## CITY OF GAINESVILLE PLANNING DIVISION DEVELOPMENT PLAN REVIEW SUMMARY OF COMMENTS

Petition Number: 15SUB-06DB Revi	iewed By: Lawrence D. Ca	aldersa
Reviewing Body: Development Review Board	Date: March 9th 2006	3/7/06
Project Name/Description: GBlues Creek Unit 7		
Plan Reviewed: Thursday, March 9th 2006	Review For: Alison	Feter Engineering, Agent for
Blues Creek Development, Lt. Design Plat Revie	w to allow 16 lots on $2.37$	Acres. Zoned PD,

Petition No. <u>15SUB-04DB</u> Review Date: 3/9/2006	Review Type: Preliminary Final Amend.
Reviewed on : 3/06/06 Review For: Alison Fetner, P.E. Agent for Blues Creek Development, LT. Design Plat Review for 16 Lots on 2.37 Acres. Zoned PD (Planned Development). Located in the 4900 Block of NW 73 <sup>rd</sup> Avenue, North Side.	Project Planner: <u>Lawrence Calderon</u> 3/2/06.

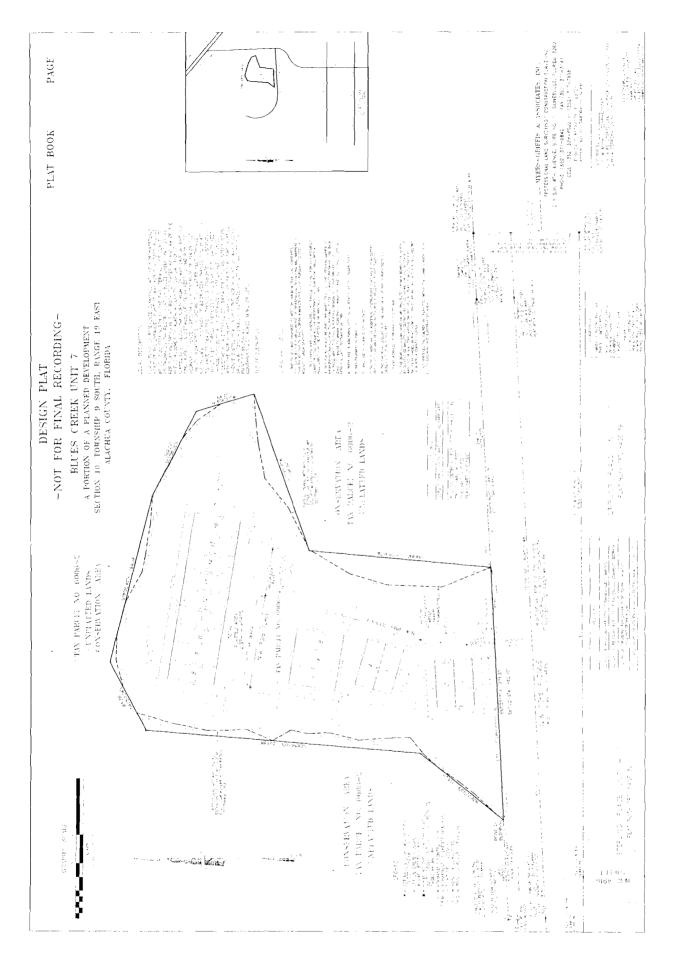
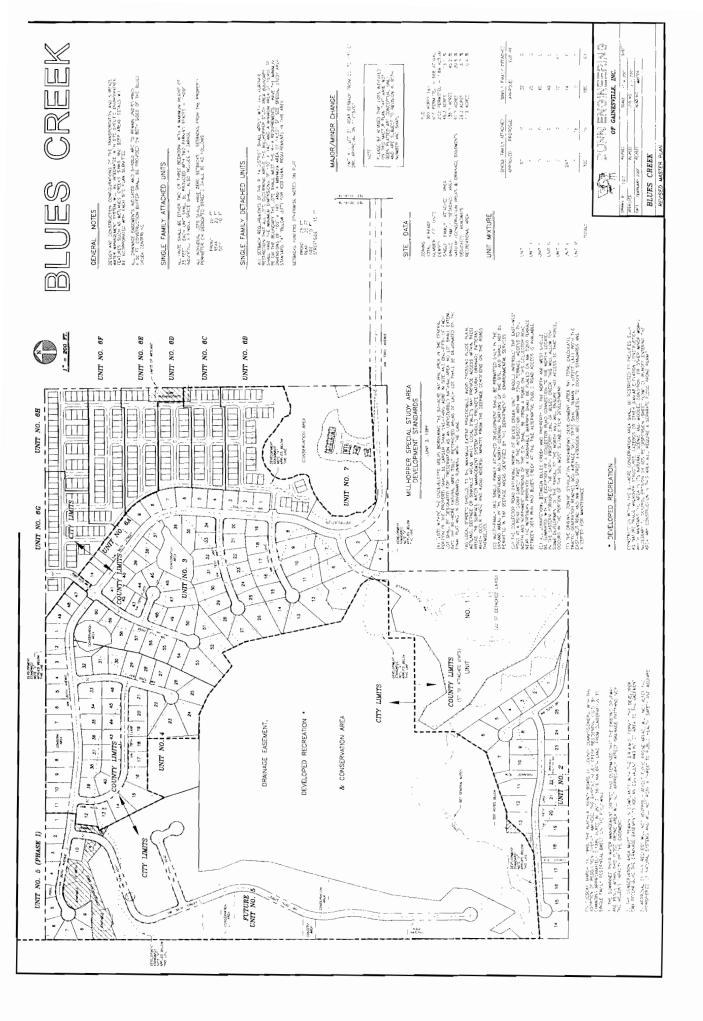
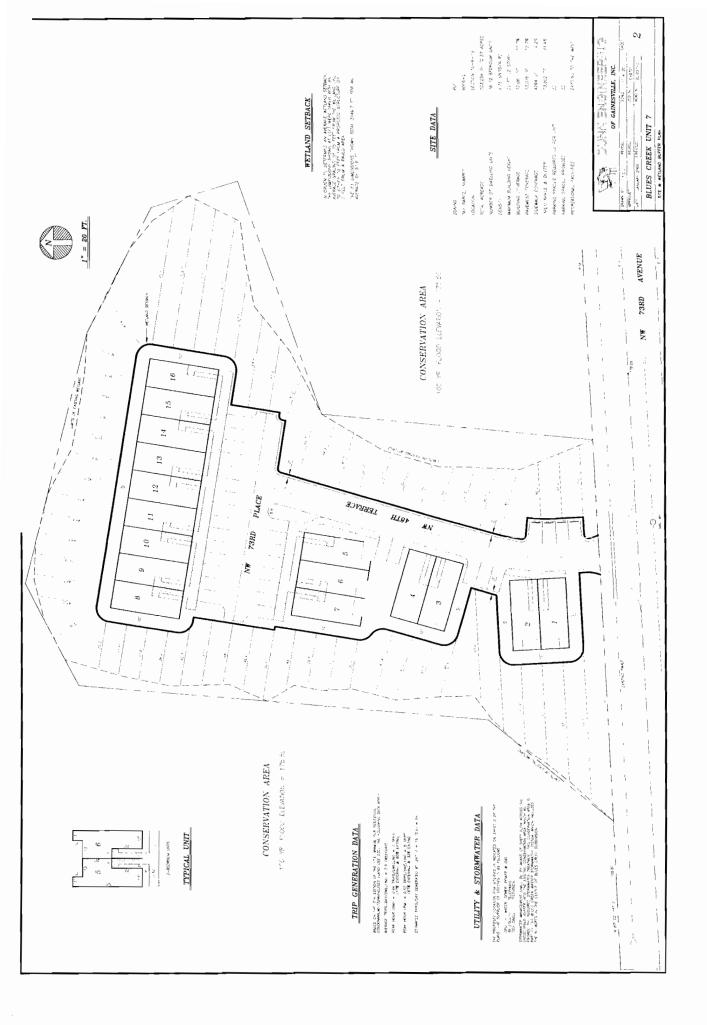
- 1. There are disturbances and construction proposed in the designated buffer areas for the wetlands.
- According to the wetland ordinance, "Buffers shall remain in an undisturbed condition. The buffer line is approximately 10 from structures on the parcel. Every effort should be made to ensure that there are no impacts to the wetlands.

- 3. Show the data that justifies that the average of 50 feet is satisfied.
- 4. This petition only addresses design plat. Construction of those units will require development plan approval. A separate appropriate application for development review is required.

The current plan notes what should be a wetland buffer as a "setback. There is a distinct difference between setback and buffer. For example, a development setback is a physical separation between a structure or other improvement and a resource boundary. Designation as a setback does not prohibit alteration within the setback area. A buffer is a protective strip of land, in this case to a wetland, that is to remain unaltered.

In addition, the buffer line is within two feet of the footprint of the buildings. This is unacceptable as the buffer will be impacted during construction and altered post development. Wetland buffers should remain undisturbed except for the allowance of stormwater systems according to City code. In this instance, stormwater treatment is not required and stormwater will be allowed to flow directly from impervious areas to the buffer, into the wetland. The ability of the buffer to function as a filter for stormwater runoff and as a preventative area for erosion and sedimentation into the surrounding wetland is based on the buffer remaining in a natural vegetated state. This will not occur with the proposed plan.

The last revised master plan as reviewed by Alachua County approved six units on this site. The recommendation for six units took into consideration the environmentally sensitive nature of the property. The upland area is a small finger like linear projection surrounded on three sides by wetland. The current plan under review by the City is proposing sixteen units on the site.; this plan does not take into account the environmentally sensitive nature of the property.

Mr. Higman noted a dark line drawn on the plan and asked if there would be a fence or wall around the perimeter of the site.

Mr. Higman asked what would keep residents of the development from trespassing on the wetland buffer and wetland itself, and treating it as if it were part of their yards.

Mr. Shatkin asked if there was a requirement for a building setback from the wetland buffer similar to a lot line buffer. He asked if a building could be constructed at the very edge of the wetland buffer.

Chair Cooper noted that the comments from the Alachua County Environmental Protection Department (ACEPD) expressed a concern about the two-foot separation between the buffer line and the buildings. She asked if the proposed new 10-foot separation was in response to that comment. She noted that ACEPD considered two feet separation from the buffer unacceptable.

Mr. Calderon indicated that the line simply indicated the perimeter of the wetland buffer.

Mr. Calderon explained that staff usually addressed that matter during development plan review, however, it would be a violation to disturb the wetland buffer or the wetland.

Mr. Calderon explained that the undisturbed buffer was the setback from the wetland. He noted that, while a building could be constructed at the edge of a wetland buffer, the potential environmental impacts of that construction would have to be addressed.

Mr. Calderon indicated that the comments from ACEPD were based upon the two-foot separation between building and wetland buffer, and he had received no comments on the 10-foot separation. He explained that there had been problems in the past when buildings were constructed too close to a wetland buffer and ACEPD usually recommended a 10-foot distance.

Ms. Fetner indicated that while she found the 10 feet acceptable, one solution to the problem would be to require a chainlink fence with silt barriers during construction. She noted that the fence could be removed at completion of the project. She explained that the wetland was the stormwater treatment facility for the project. She indicated that she would place a chainlink fence on the project in addition to the extra 10 feet if the board wished.
